Product Change Notification

112679 - 00

Change Notification #: 112679 - 00
Change Title: Intel® Server System R1304GZ4GS9
PCN 112679-00, Product Design
Update BIOS/ME/BMC/FRUSDR Firmware
and Rear Panel
Date of Publication: October 29, 2013

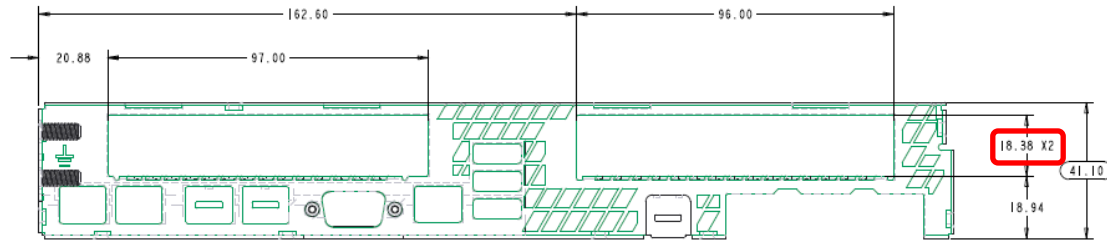
1. Update the system rear panel so that more PCIe devices and cable connectors (e.g. SFP+ PCIe card) can mechanically fit into the system. Please refer to below pictures for details:

Pre-change:

Post-change:
